Michael Casey
385 Maple Street, Stowe, Vermont

Inspection date
July 09, 2020

Reason for inspection
Transfer of property

Prepared by
Mike Remington - CSIA #9922
Brickliners Corp

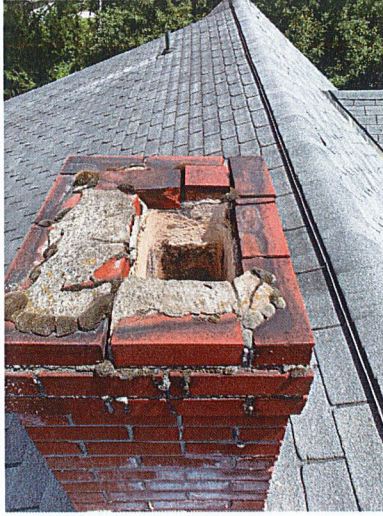
- **Mortar Condition:** Does not meet industry standards

There is significant deterioration, or missing mortar between the bricks. This can not only allow water intrusion into the chimney and cause potential leaks inside the home, but it also allows water into the chimney which can damage the chimney structure. The chimney is potentially unstable

- **Crown / Wash cap:** Does not meet industry standards

The crown / wash cap of the chimney is not constructed in a way that properly protects the chimney. The crown should be constructed with concrete. It must have an expansion joint around the flue tile. It should overhang the main structure to allow a drip edge to protect the chimney. A properly made crown will help protect the chimney from water intrusion and damage.

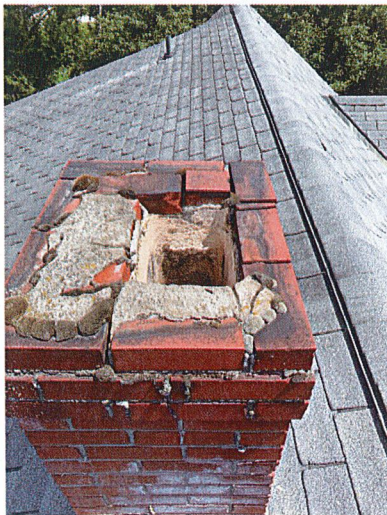
• **Brick / Stone / Chimney walls condition: Deteriorated**

The bricks are cracked and / or deteriorated and should be replaced

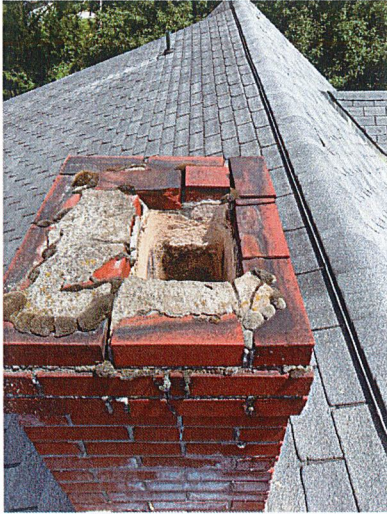
- **Height of liner above crown:** Does not meet industry standards

Due to deterioration the flue is no longer extending the required 2" above the crown.

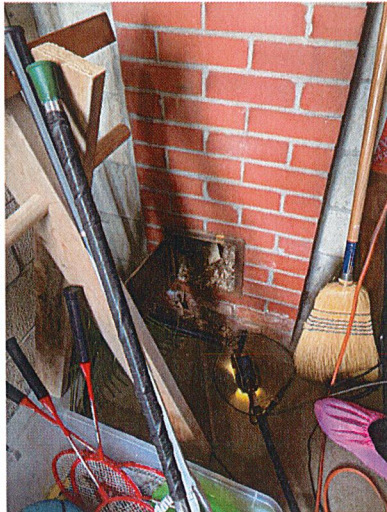
- **Installation and condition of offsets in flue if present:** Not applicable
- **Chimney cap / spark guard / Top damper:** Needs attention
The chimney cap is rusty and should be replaced. A rusty chimney cap will allow rust stains to stain or damage the lower structure
- **This flue was inspected:** Internal camera inspection system
- **Chimney liner / re-lining system support:** Meets industry standards

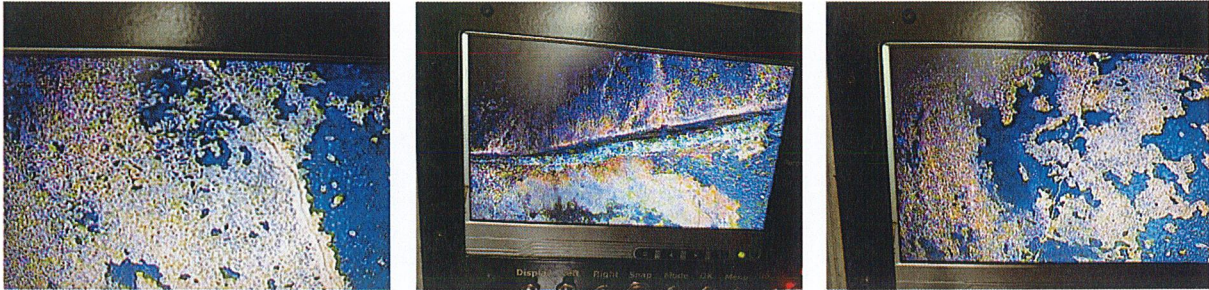
- **Flue shape (used to determine flue size ratio to fireplace opening):** Rectangular
- **Verification that the flue is not blocked or significantly restricted or obstructed:** Meets industry standards
- **Indications the flue is not drafting properly:** No
- **Chimney liner presence, condition regarding readily visible defects, holes, cracks, missing mortar joints, spalling, mortar protrusions, and proper alignment:** Does not meet industry standards

There are tiles that have vertical cracks. Vertical cracks are an indication that there has been a sudden rapid heating of the tile. This rapid heating causes thermal shock to the tile. Thermal shock causes the inside of the tile to heat more rapidly than the exterior of the tile. Heat causes the inside of the tile to expand more rapidly than the exterior of the tile. When this occurs the tile will crack vertically. This flue tile can no longer perform its intended function. The chimney must be relined. 2016 NFPA 211 14.9
